RE: Remarkables Ski Area Upgrades and Doolans Expansion – Response to Landscape Feedback

PEER REVIEW MEMORANDUM REGARDING LANDSCAPE AND VISUAL EFFECTS ASSESSMENT

DOC Memorandum on NZSki Landscape Effects Assessment

Image 1: Export from 3D terrain model

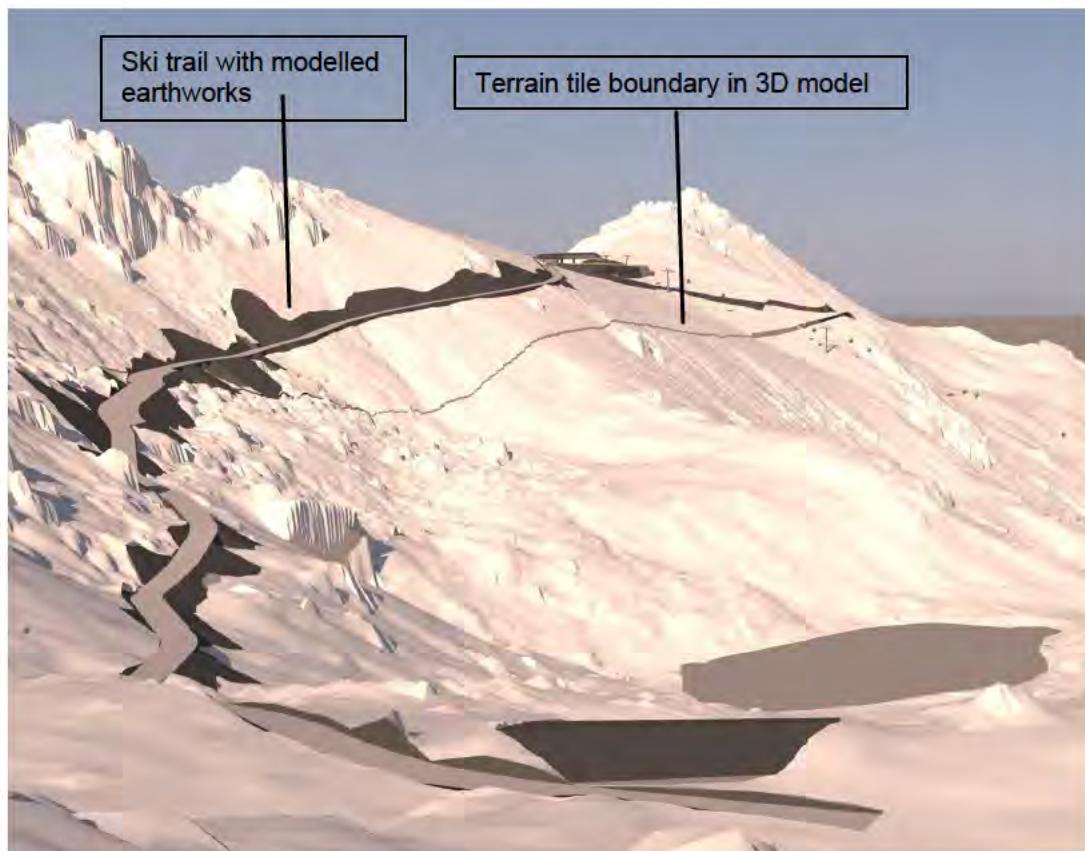
In the conference call, Mr Head requested additional graphic material to better understand how the mid station integrates into the local landscape context, including the retaining walls (up to 8.5 m high and 70 m long) that is proposed below the mid-station building. An additional graphic attachment (attached to this memorandum) was prepared by BML that contains view comparisons between photographs taken of the mid station and exports from the 3D model that was utilised to prepare the visual simulations dated 7 May 2026 (see Substantial Application). It was noted that the visual simulations did not provide views of the mid station from within Sugar Basin and the Doolans.

It is noted that the exports from the 3D model have not undergone any image editing, and therefore the mesh lines between terrain tiles remain visible. These lines appear on all exported images similar to the earthworks for proposed cuts for ski trails, but lighter in colour, located below the proposed ski trail from the mid station (as illustrated on image below).

The additional exports show both the mid station building and the earthworks required to establish the structure, including the proposed retaining walls and lift towers. In views within the ski field (see pages 1-10) the platform/retaining wall and lift tower will partially appear on the skyline, with the midstation structure itself largely out of view. For more distant views, the midstation will partially appear on the skyline (see visual simulation 3). However, in these views the structure is a comparatively small element.

On the Doolans side of the ridge the midstation is within a up to 10m high cut, but in nearby views from immediately below the structure (see Model view p.18) the mid station would protrude on the skyline. However, as shown in the ZTV, the mid station is obscured from substantial parts of the Doolans basin by intervening ridgelines. Pages 13-16 illustrate views of the mid station in views along the ridgeline to show the cut (Doolans side) and fill (Rastus Burn side) required to construct the platform. It is acknowledged that the visual effects of the mid station will be high when viewed within its immediate context along the ridge or from immediately below on the Doolans side. However, I maintain the view that visual effects of the mid station from the Rastus Burn side are mostly moderate, as the retaining wall partially obscures the structure in short-distance views and in long-distance views the structure is a relatively small element on a rocky ridgeline.

VIEW COMPARISON

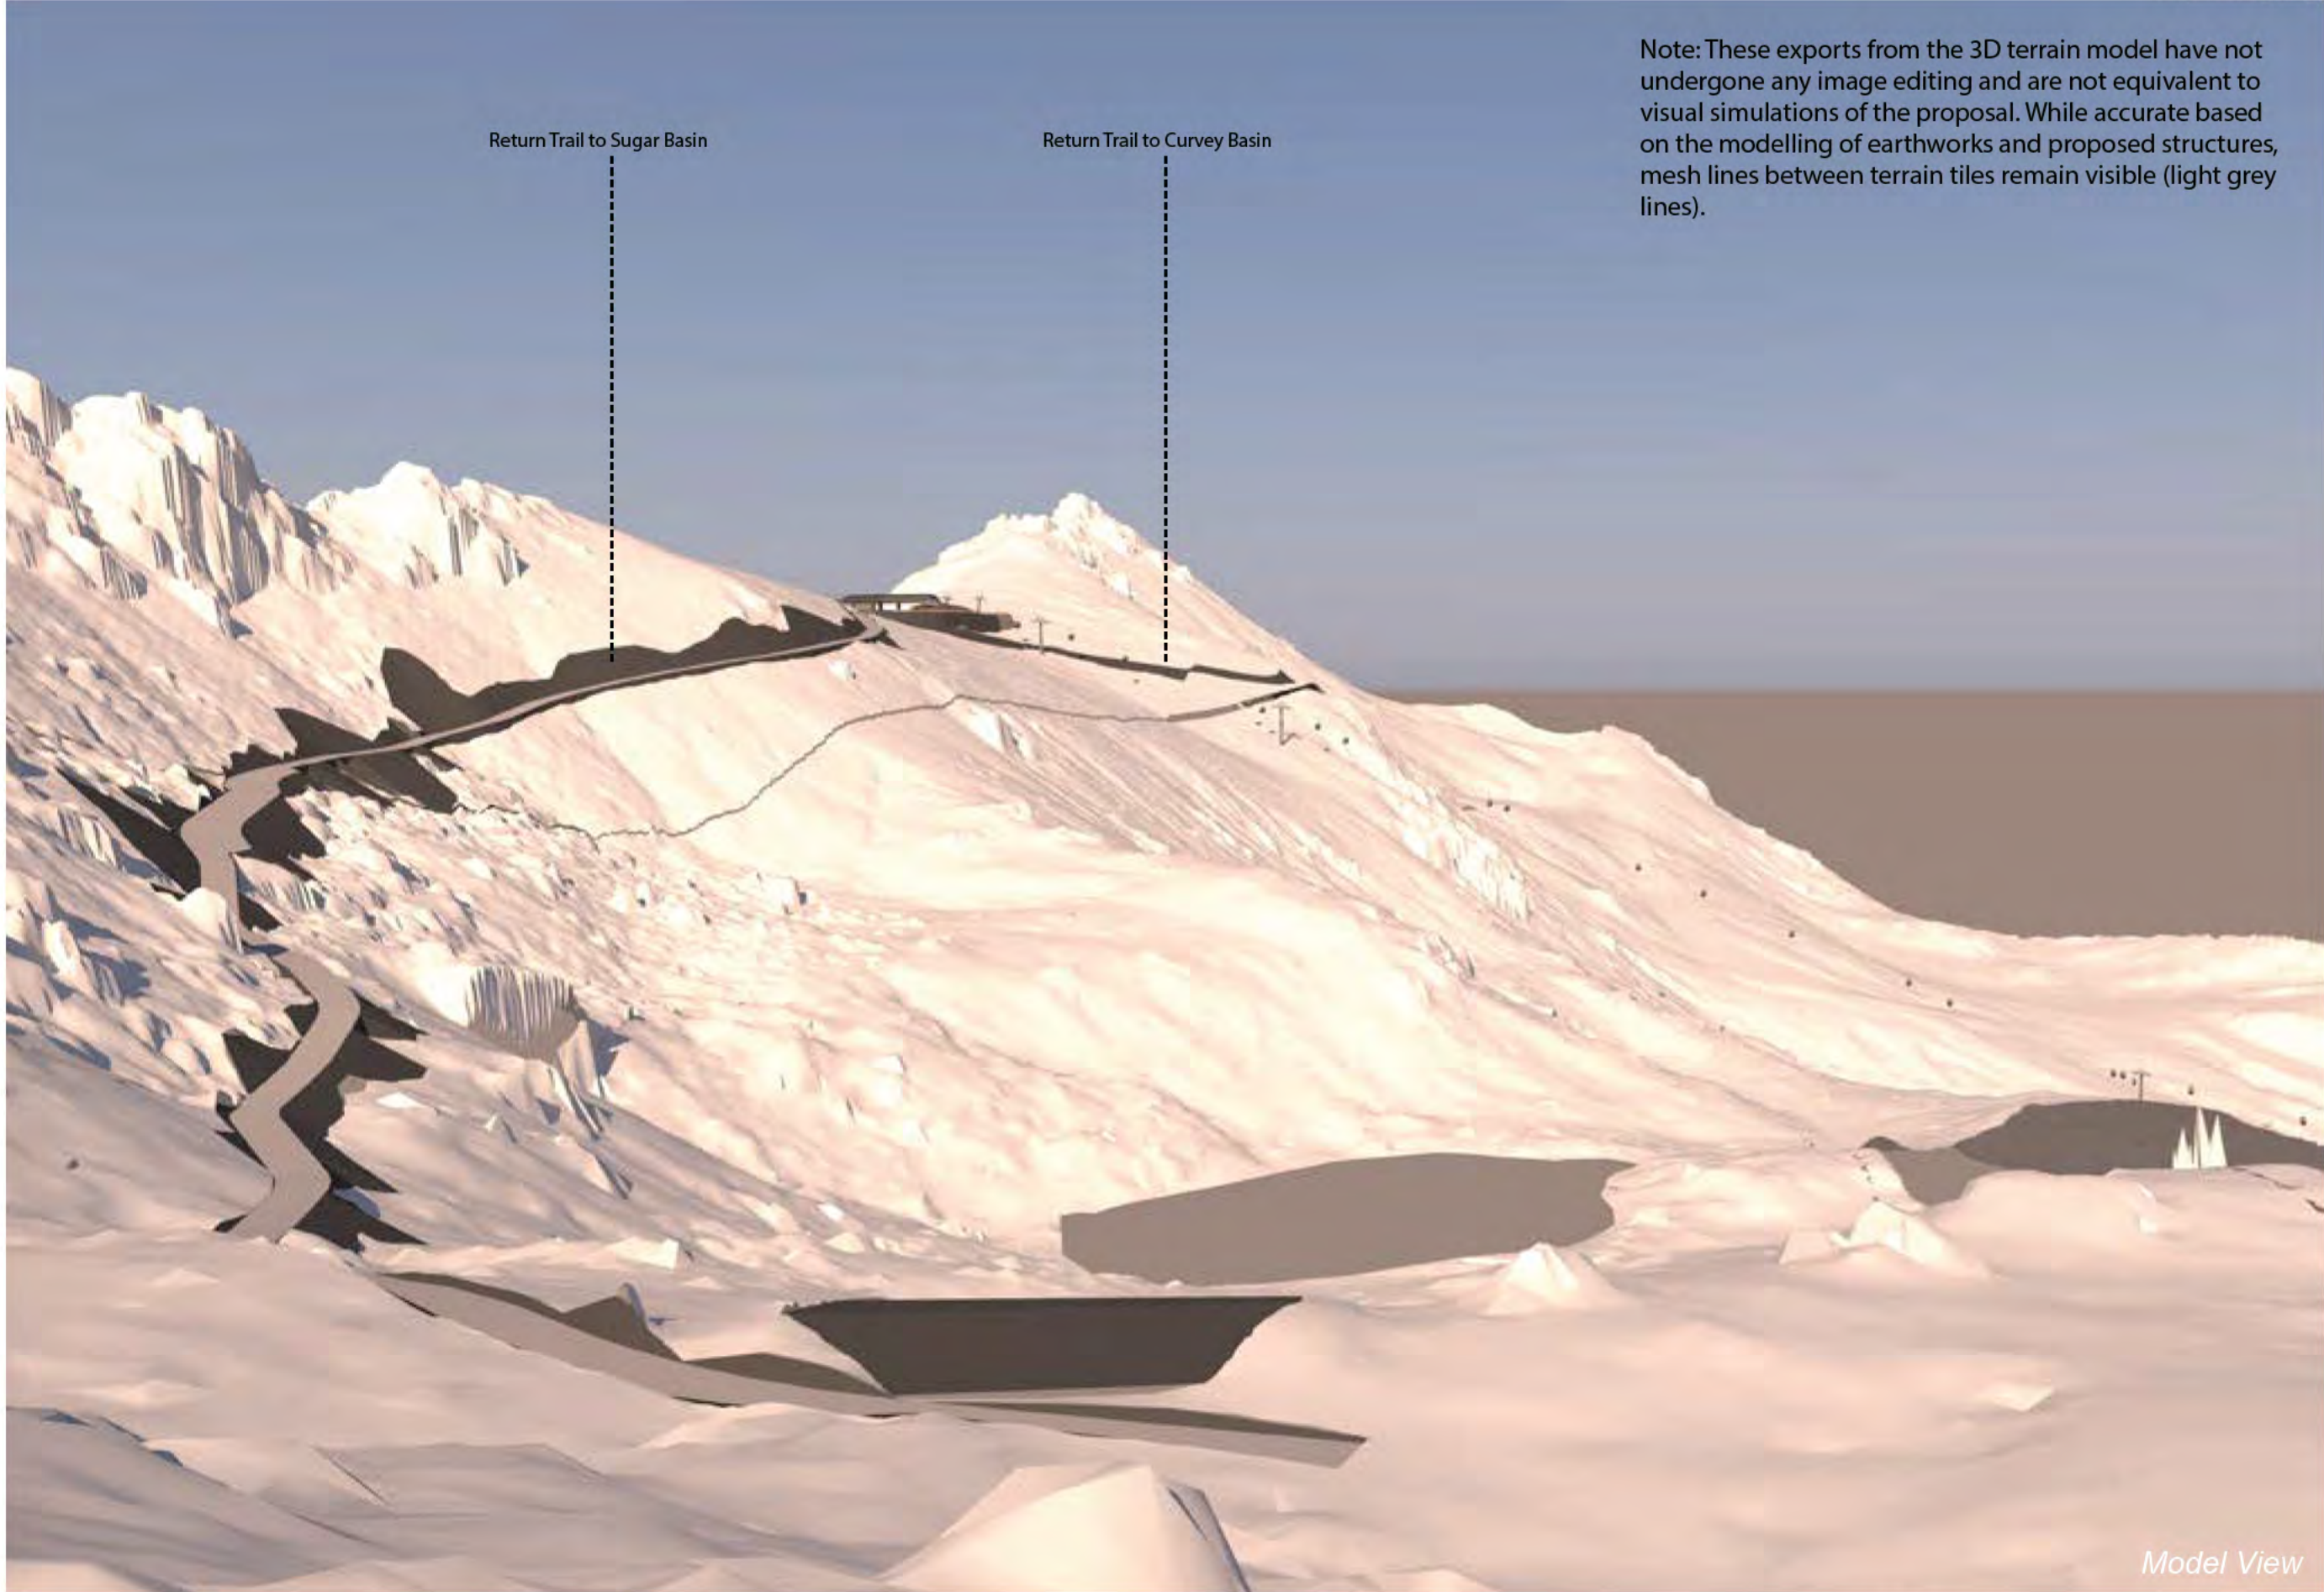
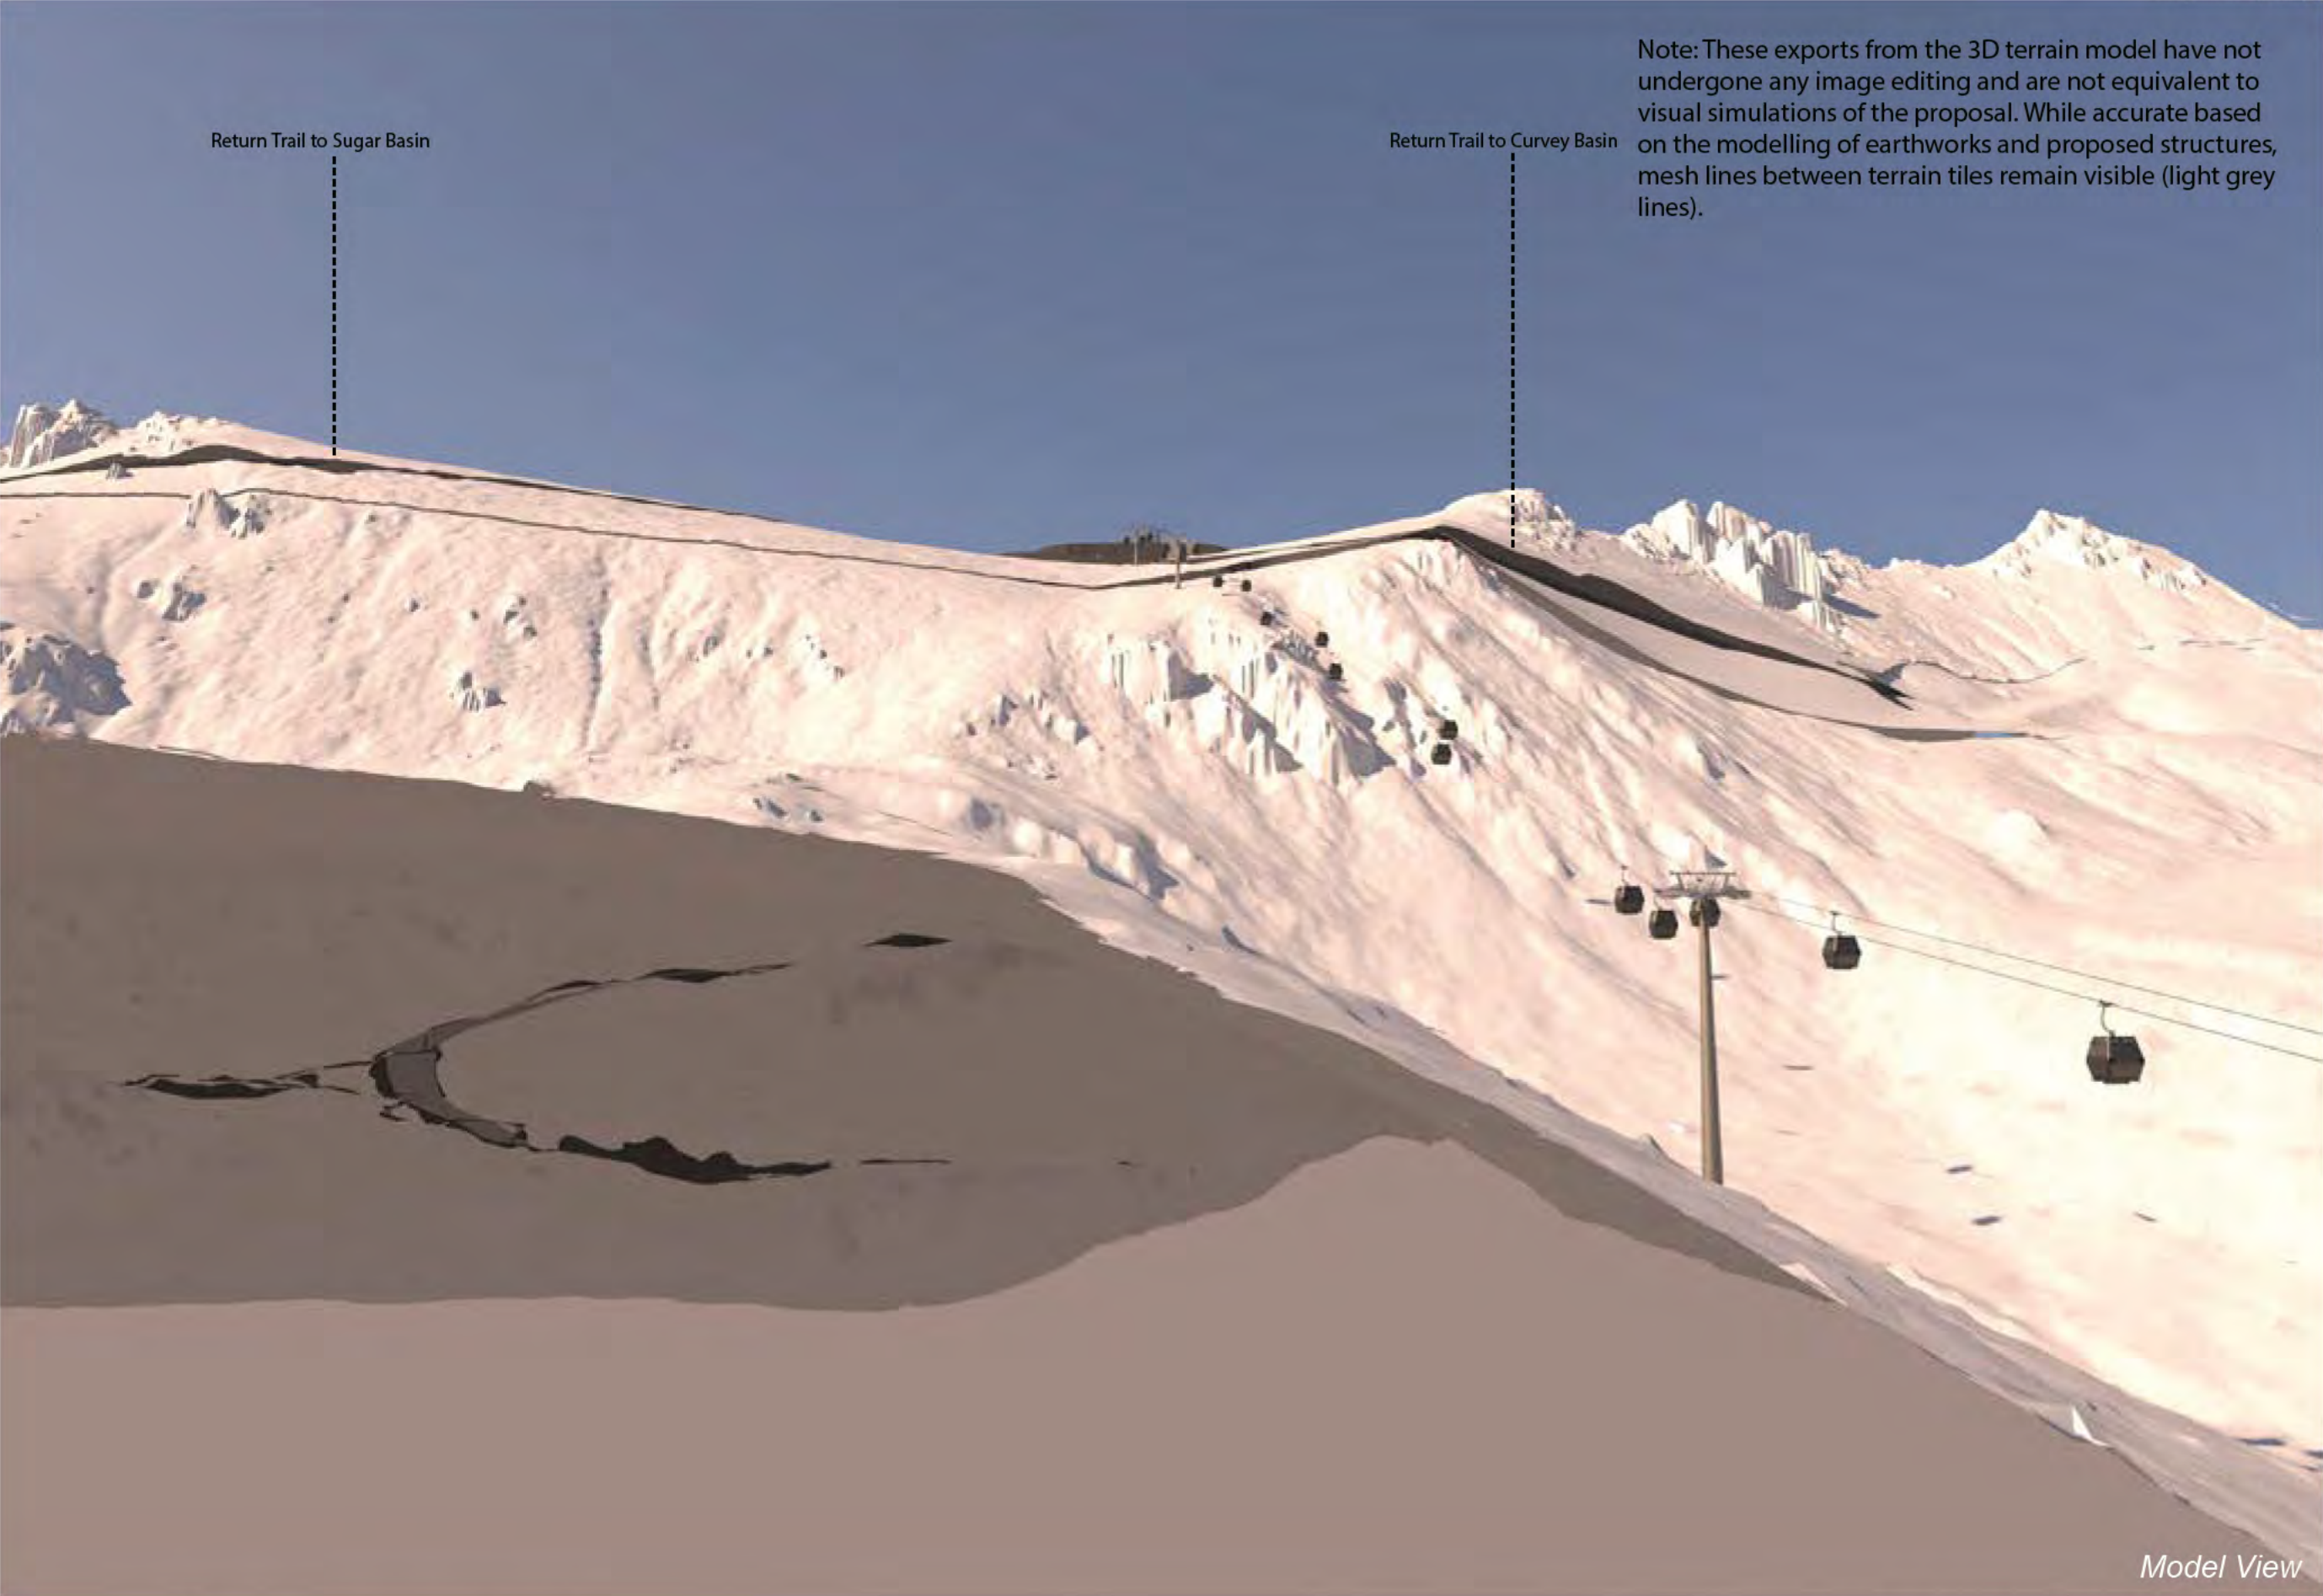
2. NZSki to provide views of the proposed mid-station in relation to the surrounding landform and landscape context.

19. The mapping in the 6 May 2026 B-031.1 Remarkables Ski Area Upgrade and Doolans Expansion Landscape Graphics (Figures 1, 2 and 4) is at a scale / level of detail where it is difficult to see where the proposed gondola mid-station is located. It is important that the various areas (QLD area and its mapped SASZ, the COD area, Rastus Burn Recreation Reserve and ridgeline) are accurately mapped along with the location of the mid-station building.

- > See attached Boffa Miskell memo and graphic supplement (**Attachment 3**)
